Humboldt Regional Climate Action Plan and CEQA GHG Emissions Thresholds

Final Environmental Impact Report

State Clearinghouse #2024081319

November, 2025

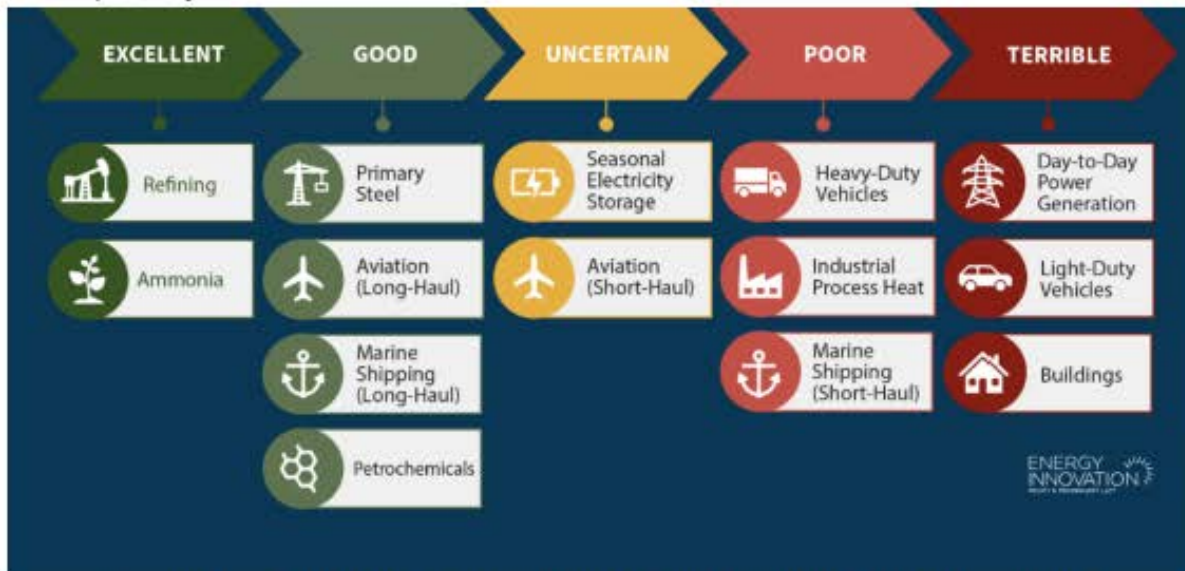
- "Renewable natural gas" is primarily dairy biogas upgraded to biomethane. The LCFS erroneously assigns it negative carbon intensity values because dairy methane is not regulated. Our climate action plan cannot be predicated on the lack of regulation of the largest single source of anthropogenic methane in the state.

- The current draft of LCFS regulations adds a cap to renewable diesel, and, because it indirectly causes deforestation, it is not considered a climate mitigation in Europe. Our CAP cannot be based on an industry that is contributing to loss of forest sequestration.⁵⁵

102-52

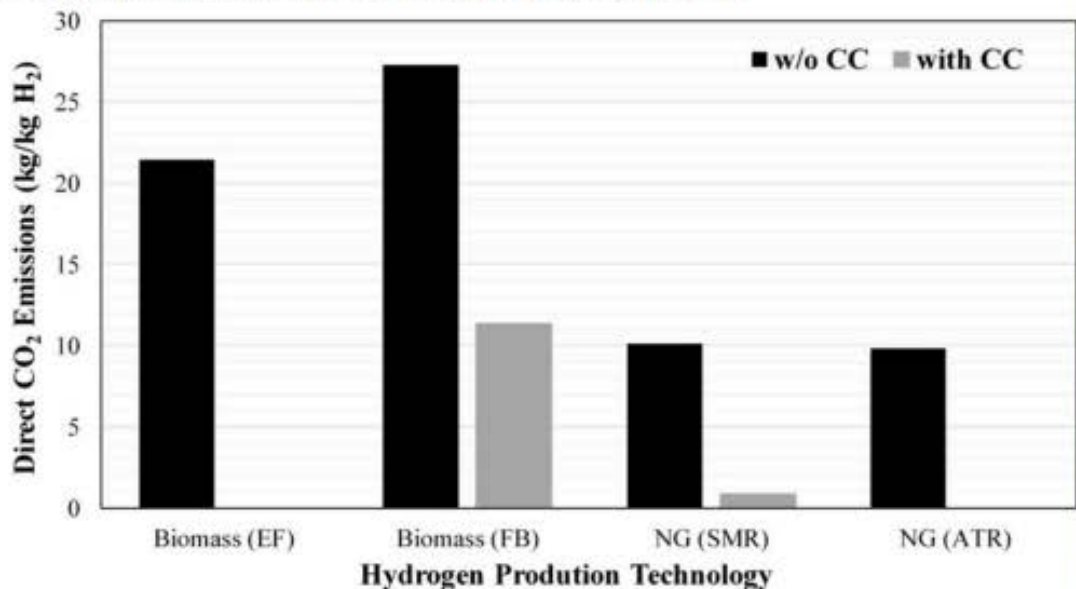
- Hydrogen is widely considered a climate-neutral energy source because when combusted it does not produce CO₂. However, if leaked into the atmosphere it has a warming effect because it reacts with methane and ozone. Because it is such a small molecule, "fugitive" hydrogen is a concern.⁵⁶
- "Green hydrogen" is needed for certain very difficult to decarbonize sectors, such as steel and cement and aviation. The graph below, from a just released report by the highly respected think tank Energy Innovations makes clear hydrogen has a narrow pathway.⁵⁷

102-52
cont.

- However, there is virtually no green hydrogen available at this point. The Inflation Reduction Act contains large incentives for green hydrogen and it is hoped that by 2030 that industry can take off.⁵⁸
- The CAP should not endorse the use of any hydrogen for light vehicles, including fueling stations for light vehicles. HTA will be bringing fueling stations for buses and presumably some trucks and perhaps port equipment. 350 Humboldt supported the HTA grant on the assurance that the hydrogen would be green by 2028.
